## ANNEXURE "B"

Re: Australian Catholic University Part 3A Application  
Application No.: MP10-0231  
Property: Barker Road, Strathfield  
Client: Strathfield Council  
Project Number: 12-016

Figure 3: Precinct 1 Perspective View looking North Before and After

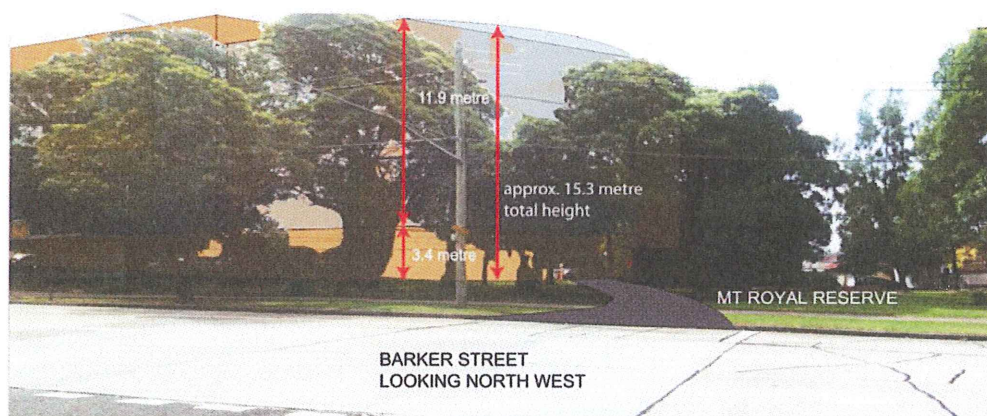
The proposed development is excessive because it is markedly different to the bulk and scale of the existing campus setting, and that of the adjoining Strathfield low density residential area. The existing campus has an estimated<sup>1</sup> 9,000m<sup>2</sup> of gross floor area (GFA) with the proposed expansion allowing for a maximum additional GFA of <sup>2</sup>14,850m<sup>2</sup>. This equates to a total GFA on site of 23,850m<sup>2</sup>

The new buildings are large and placed at the edges of the campus where they will be readily visible and in doing so change the perceived scale of the surrounding area, beyond that which may have been expected or anticipated in the surrounding low density residential area.

Figure 4: Precinct 3 Perspective view looking North Before and After

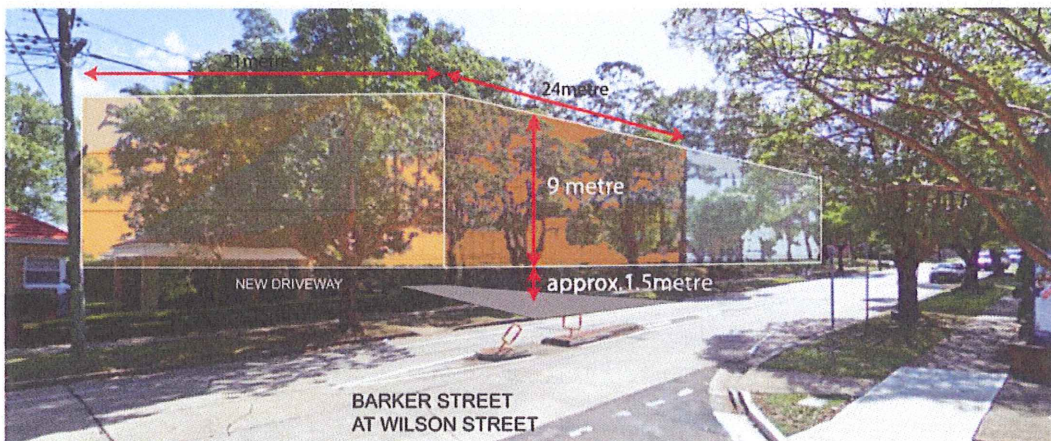
The proposal does not comply with this clause. The proposed development, particularly in terms of the height, scale and siting of proposed Precincts 1 and 3, significantly contrasts with the existing buildings (both residential and institutional) in the immediate vicinity of the site. Smaller, more appropriate buildings which are proposed are located away from the public domain in areas which are most suitable for larger buildings.

The proposed development does not integrate into the existing streetscape. The proposed buildings, in particular, Precinct 1 and 3 create an abrupt change in bulk and scale of built form. They not only create dominance in terms of the surrounding residential zone but also dominate the existing heritage buildings on the ACU campus.

Figure 5: Excerpt from 'Concept Plan: Environmental Assessment' (Source: *Concept Plan Environmental Assessment: Hassell Dec 2011 pg. 36*)

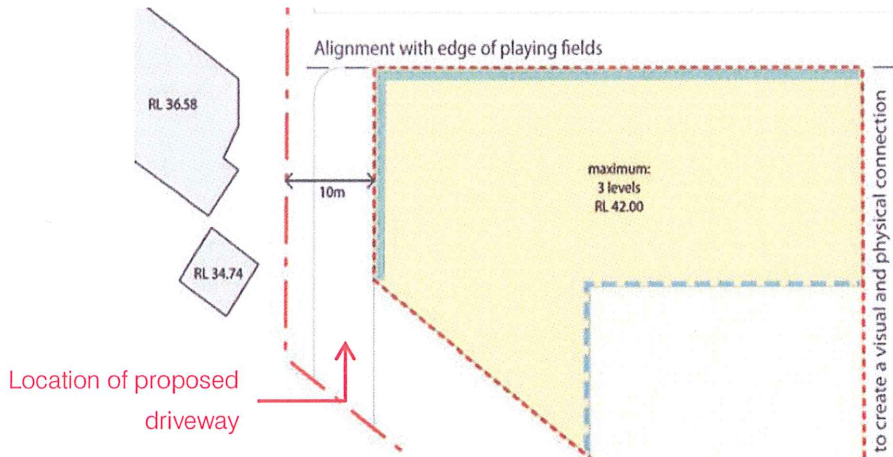
- The driveway to the proposed underground car park (Precinct 3) adjoins existing single dwellings at the western boundary. This condition shall give rise to significant impacts on the amenity of the property. Further, the proposed driveway, with its minimal setback, is likely to require the removal of existing trees at the boundary which on the Tree Removal Plan (pg 24 of the CPEA) are earmarked for retention. The limited opportunities for planting within this setback due to the access driveway will have further impacts on the adjacent residential zone.

Figure 6: 'Tree Removal Plan' from Concept Plan: Environmental Assessment' (Source: *Concept Plan Environmental Assessment: Hassell Dec 2011 pg. 24*)

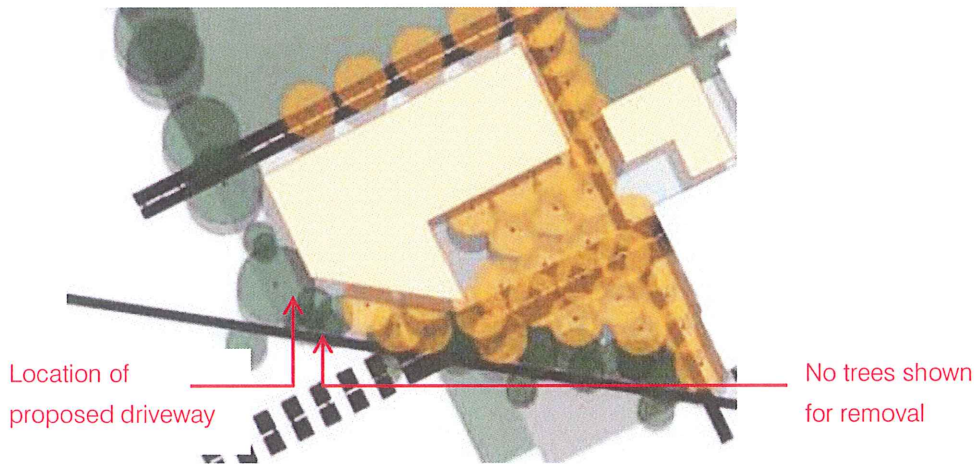
*3.4 Tree Removal* – This plan lacks is not an accurate reflection of existing trees and under estimates those trees likely to be removed when compared to the precinct plans where driveways are proposed in setback zones and changes in levels are suggested. There are a number of trees located at the two new points of entry (Gates 1 and 4) which would likely require removal. Driveway access to Precinct 1 will likely require the removal of trees within the site near the street as well as within the public reserve adjoining the development.

While it is indicated that trees are to be retained in the western side setback adjoining the existing residential dwelling, the proposed driveway to Gate 4 will likely require removal of most boundary trees.

Figure 8: Excerpt from 'Concept Plan: Environmental Assessment' (Source: Concept Plan Environmental Assessment: Hassell Dec 2011 pg. 32)

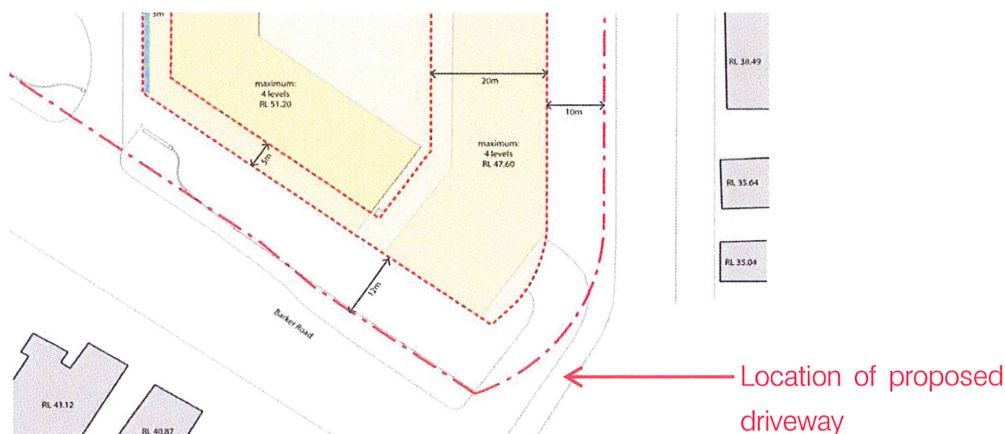
- The driveway to the proposed Precinct 1 shall impact on the amenity of the pocket park (Mount Royal Reserve) directly to the east of the site. Impacts on the pocket park shall be exacerbated by the removal of several mature trees within the existing setback area to the park. The tree removal plan (pg 24 of the SEE) does not accurately show the extent of trees requiring removal.

Figure 13: Streetscape looking East on Barker Street

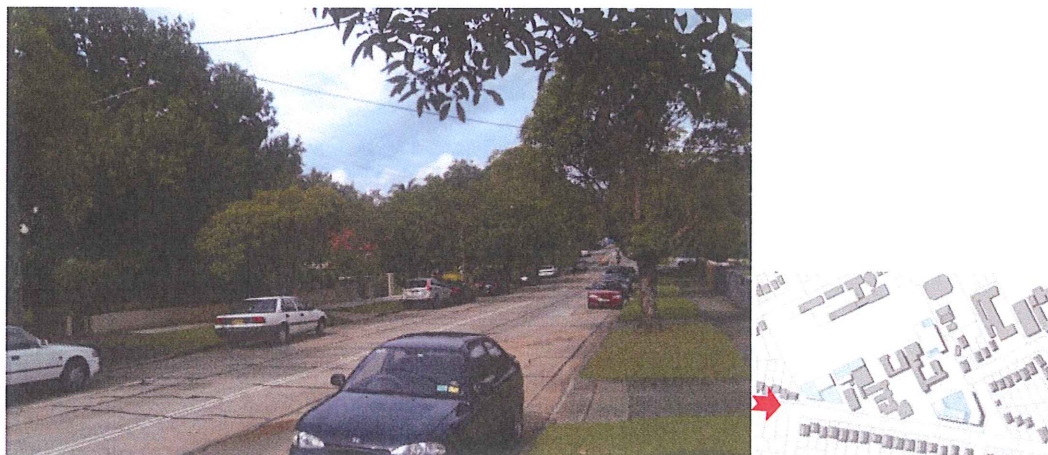
- The proposed car park access point is adjacent to neighbouring residential dwellings, and creates a conflict with the intersection at Wilson Street. There is an existing entrance used for servicing which would be readily available to be used.
- The application shows a share wall of substance adjacent to the existing residential properties. This edge of the building is significantly out of scale with the surrounding properties and lacks any cohesion with the local character of predominantly 1 and 2-storey development. While other proposed buildings have

- Ground levels as shown do not address the existing natural ground level. It will be necessary to cut and fill from the site to achieve the ground levels as stated; however, it is noted that the existing trees along the Barker Road boundary are to be retained. It is not likely that both can happen. At present there is an approximate 1.5m change in height from road level to the existing car park level, where the plans show only a minor change in grade to the road.

Figure 14: Error in RL's - 3.28m difference where section ground line is flat (Source: Concept Plan Environmental Assessment: Hassell Dec 2011 pg. 37)

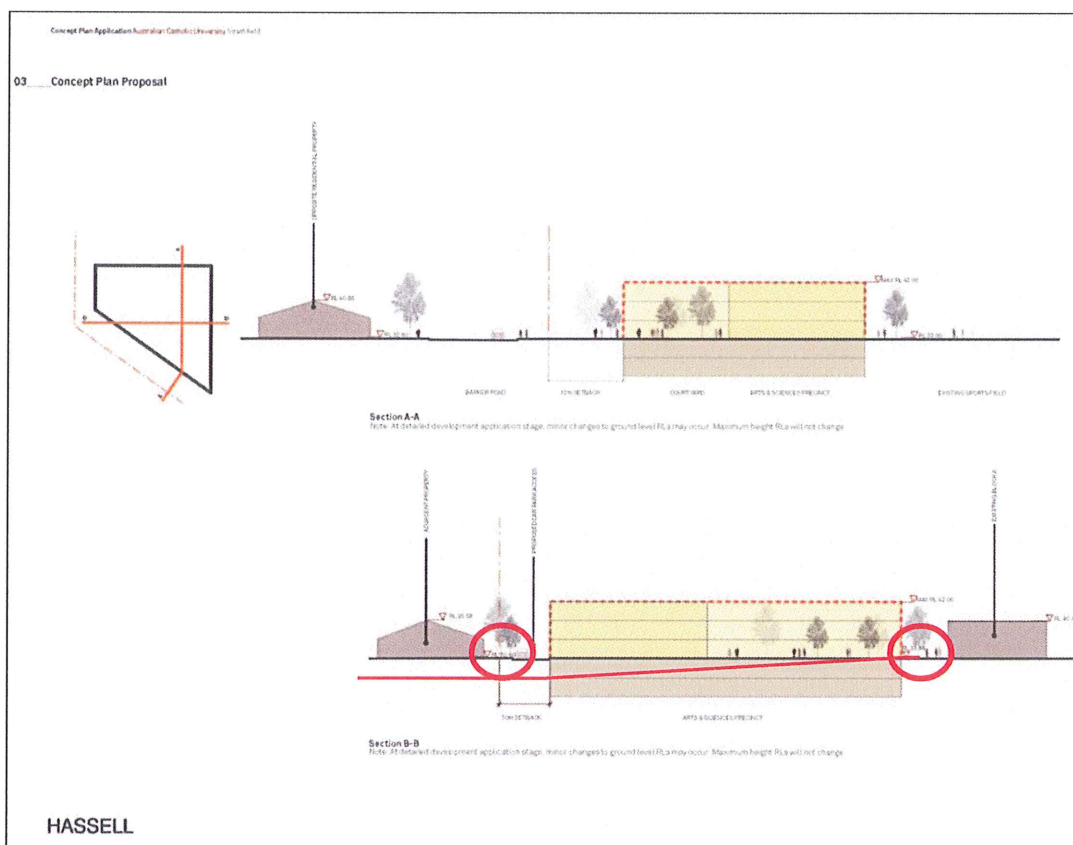
*3.11 Describing the scale of the existing built form context* – The proposal appears to utilise ridge heights in quoting RLs for existing buildings both on the ACU campus and on adjoining sites. This does not provide an accurate account of the built form

context as most of these buildings have pitched roof forms. Quoting the ridge heights serves to reduce the apparent difference in height of the proposed buildings in relation to existing. In addition, the bird's eye view of 3D modelling minimises the built form relationships between existing and proposed buildings. Views from the pedestrian level would provide a far more accurate and useful assessment of built form impacts and compatibility with the surrounding context.

Figure 14 highlights an error which significantly underestimates the significance on neighbouring properties. An error of this nature is confusing and does not portray the true nature of the development.
